RHODE ISLAND DEPARTMENT OF TRANSPORTATION

**Bridge Group 53 - Union Village RR**

NOTICE TO PROSPECTIVE BIDDERS

ADDENDUM NO. 3 Prospective bidders and all concerned are hereby notified of the following changes in the Plans, Specifications, Proposal and Distribution of Quantities for this contract. These changes shall be incorporated in the Plans, Specifications, Proposal and Distribution of Quantities, and shall become an integral part of the Contract Documents.

**LOCATION PLAN NO. 2**

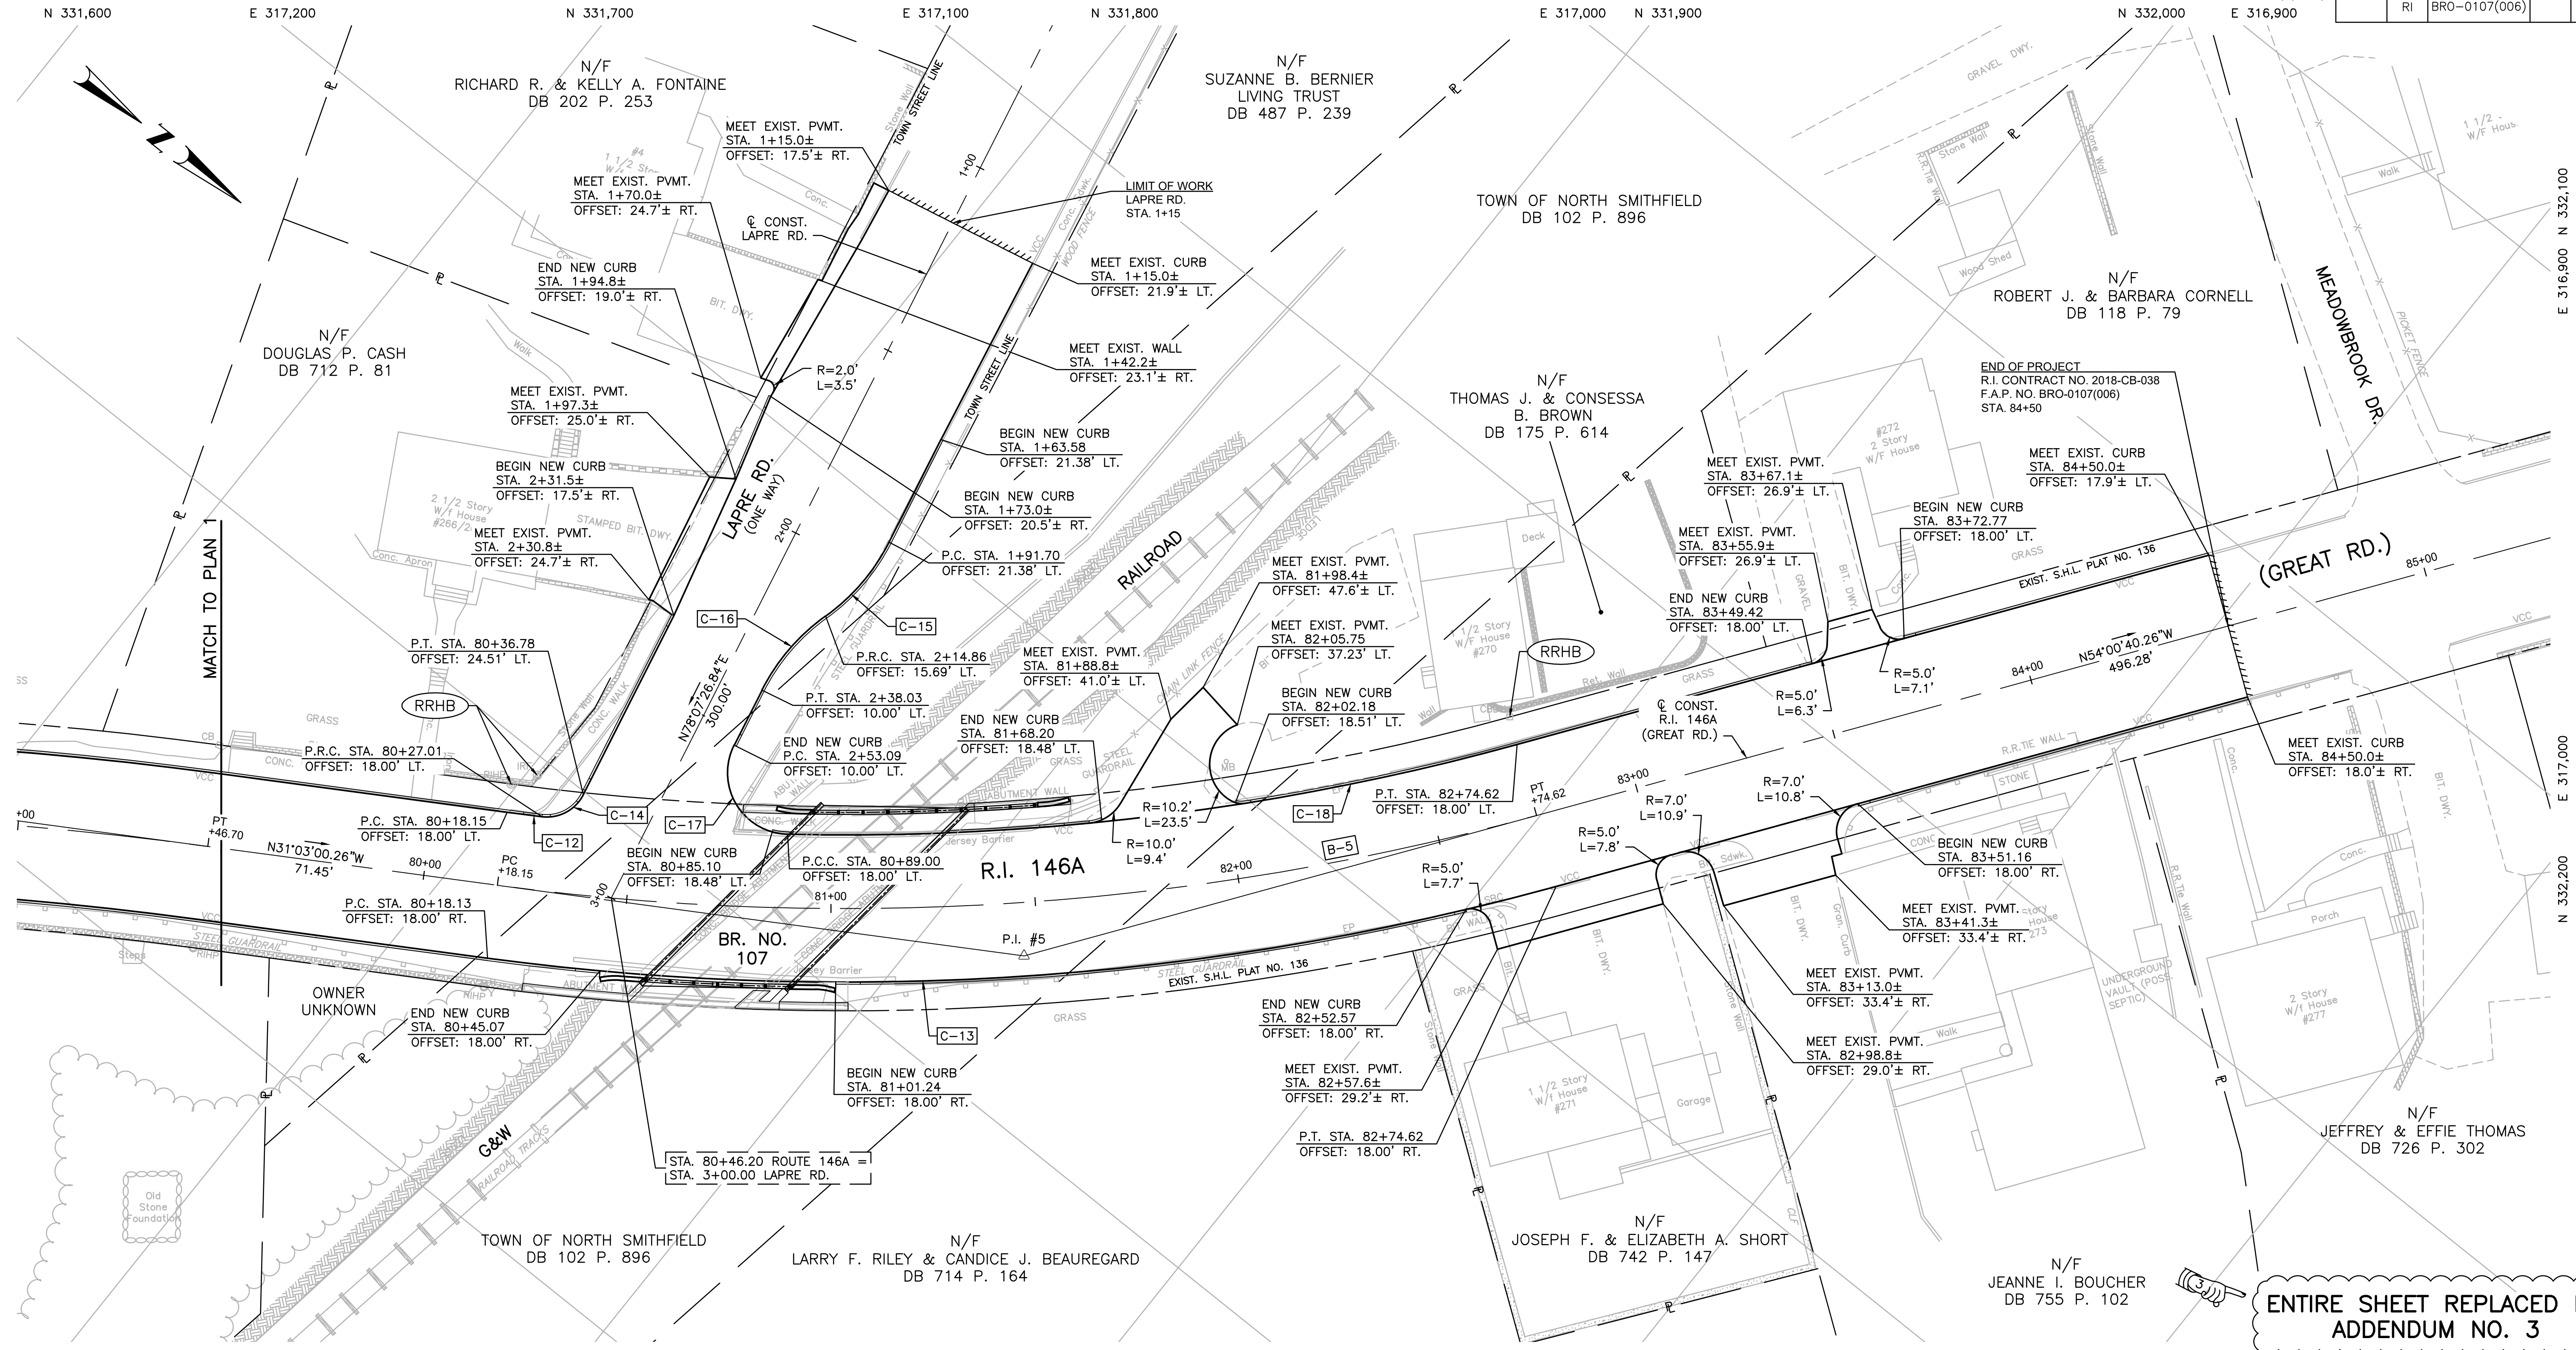
9. VOLUME 1 SHEET 18 - LOCATION PLAN NO. 2  
Remove and replace Sheet 18 in its entirety with revised Sheet 18 (R-1) attached to this Addendum No. 3. Line types have been updated to display correctly based on Sheet 2 revisions.

**LOCATION PLAN NO. 3**

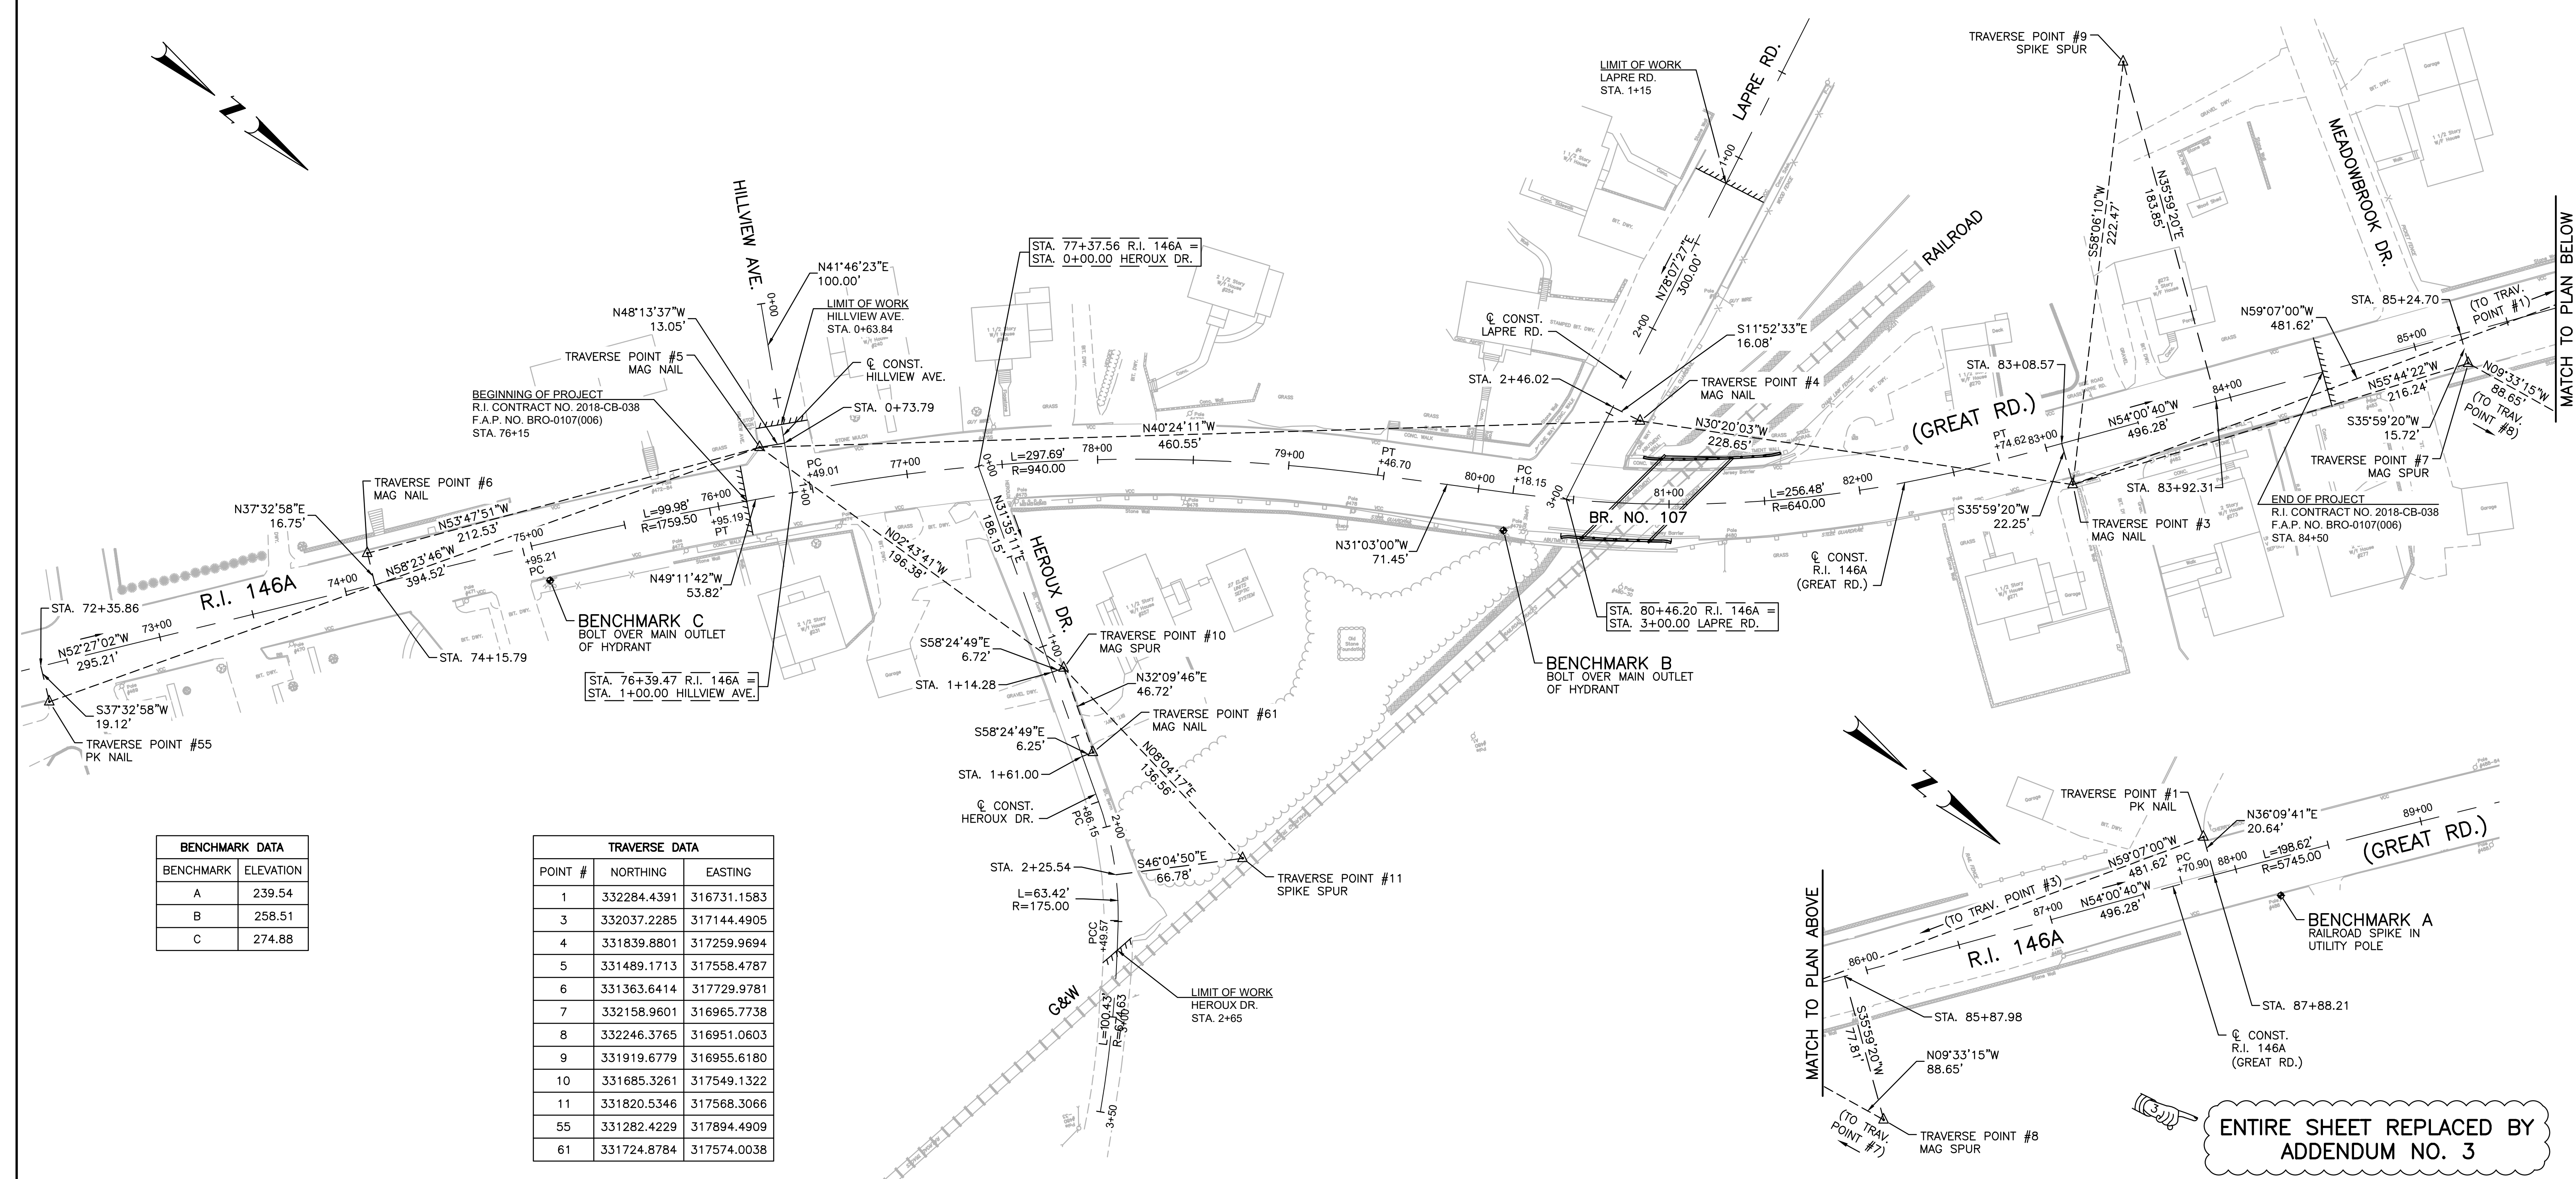
10. VOLUME 1 SHEET 19 - LOCATION PLAN NO. 3  
Remove and replace Sheet 19 in its entirety with revised Sheet 19 (R-1) attached to this Addendum No. 3. Line types have been updated to display correctly based on Sheet 2 revisions.

**LOCATION PLAN -  
 TRAVERSE SHEET**

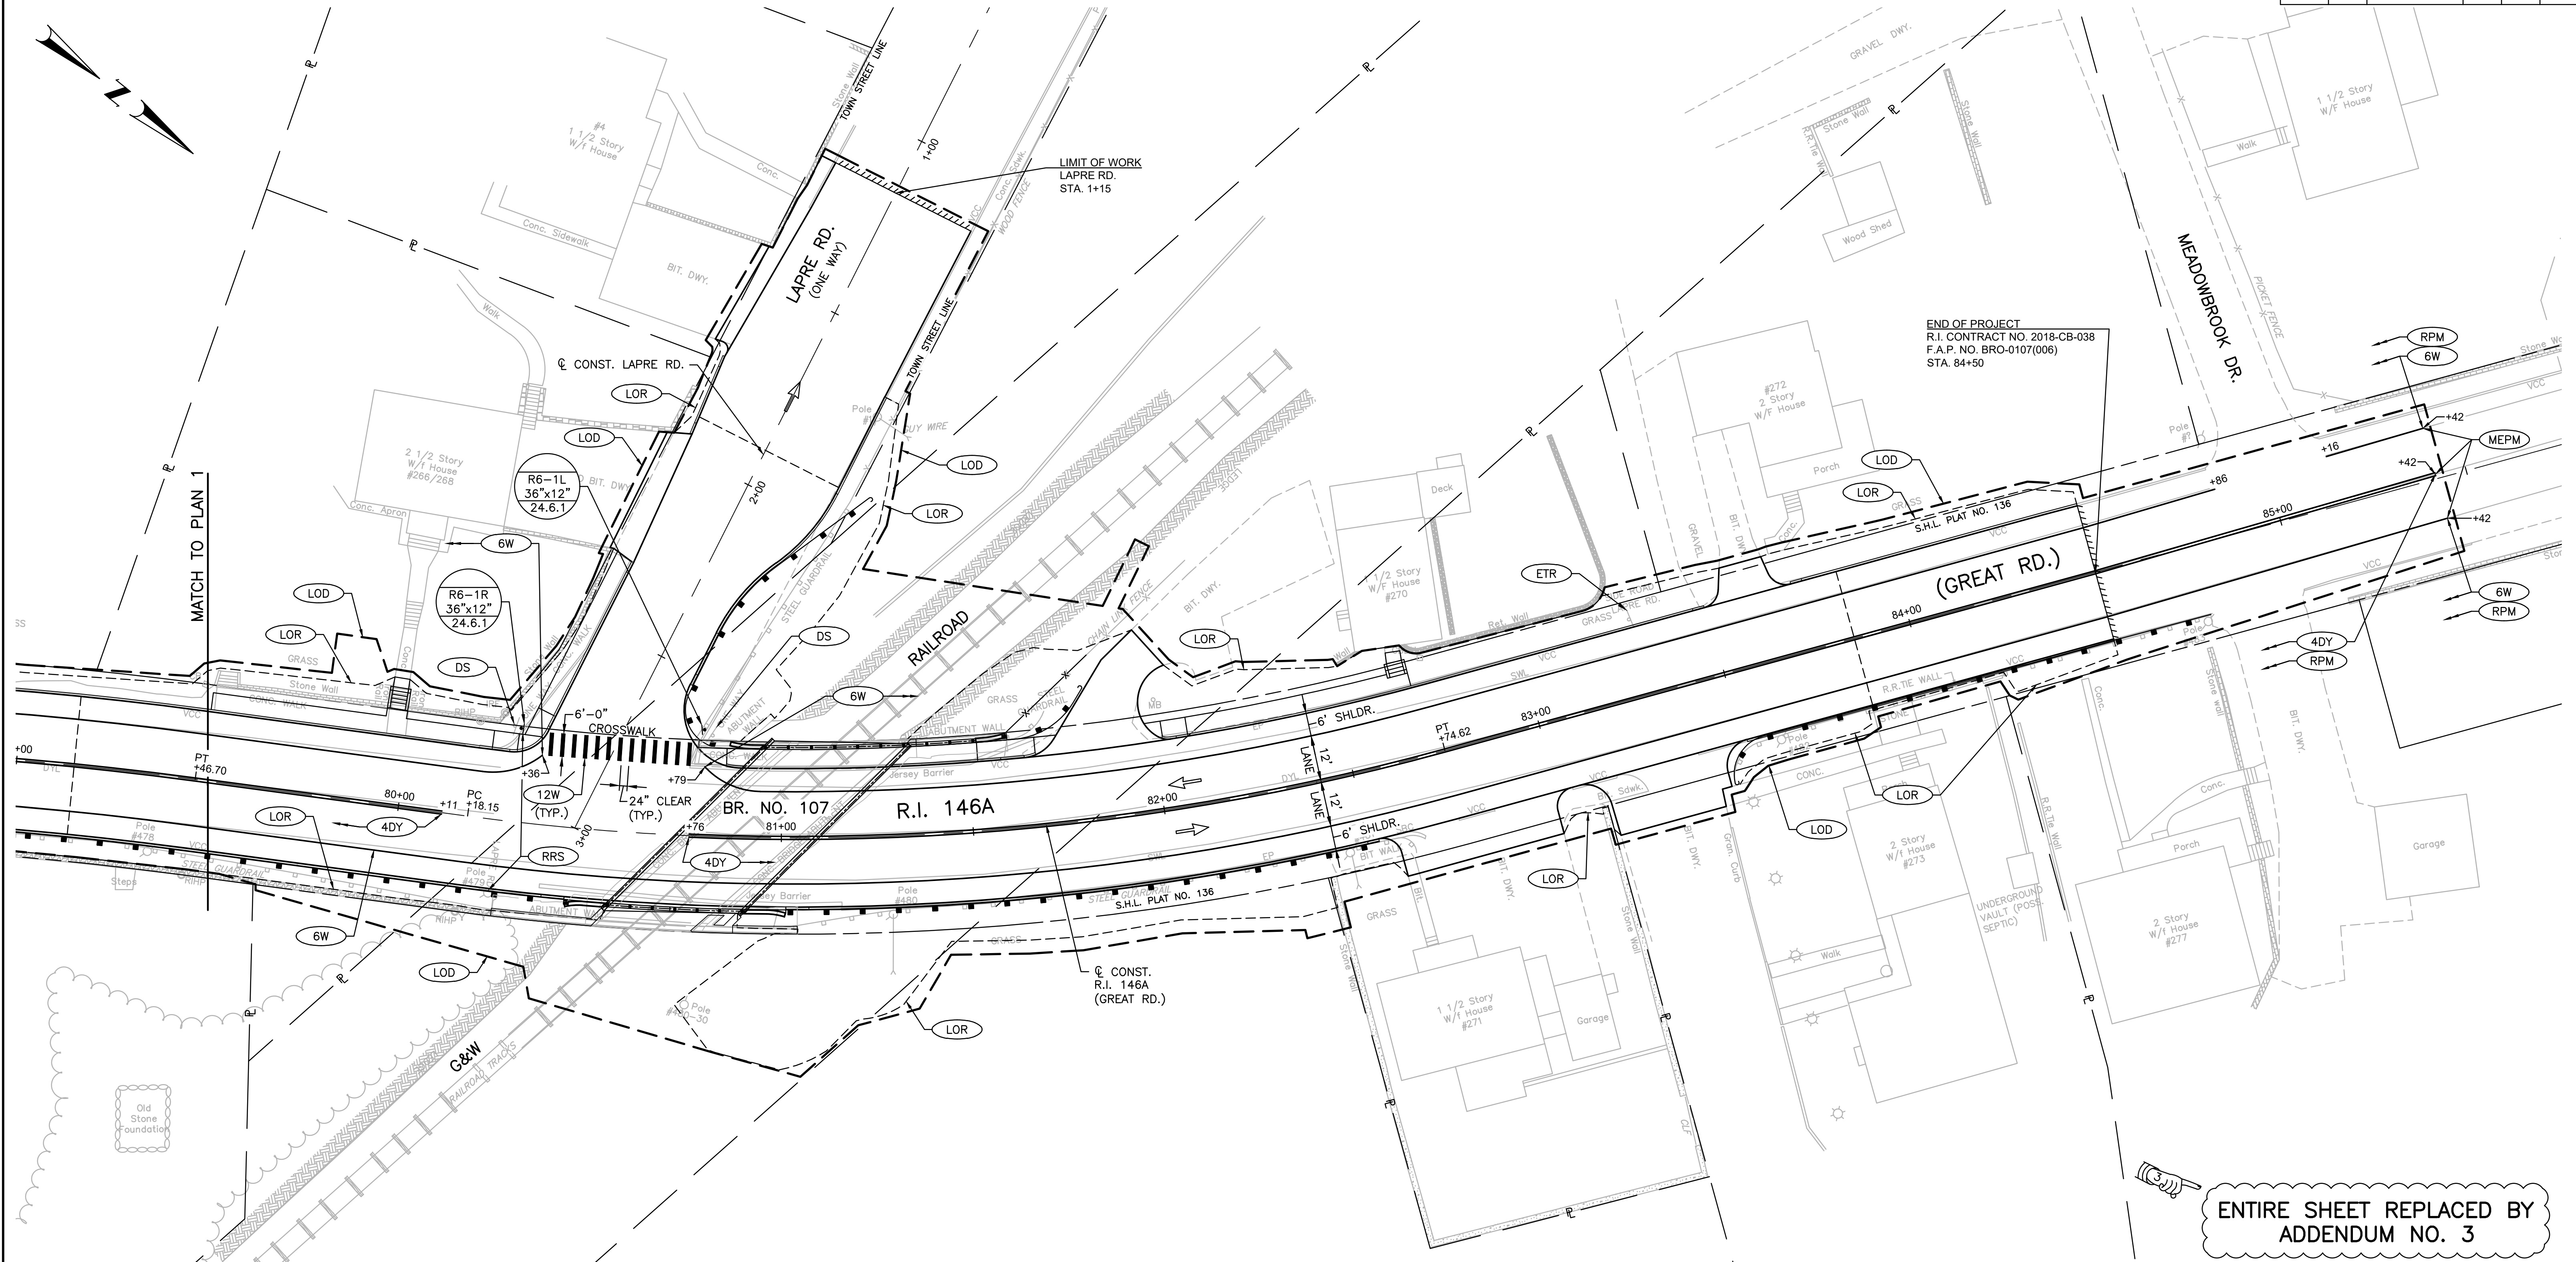
11. VOLUME 1 SHEET 20 - LOCATION PLAN - TRAVERSE SHEET  
Remove and replace Sheet 20 in its entirety with revised Sheet 20 (R-1) attached to this Addendum No. 3. Line types have been updated to display correctly based on Sheet 2 revisions.
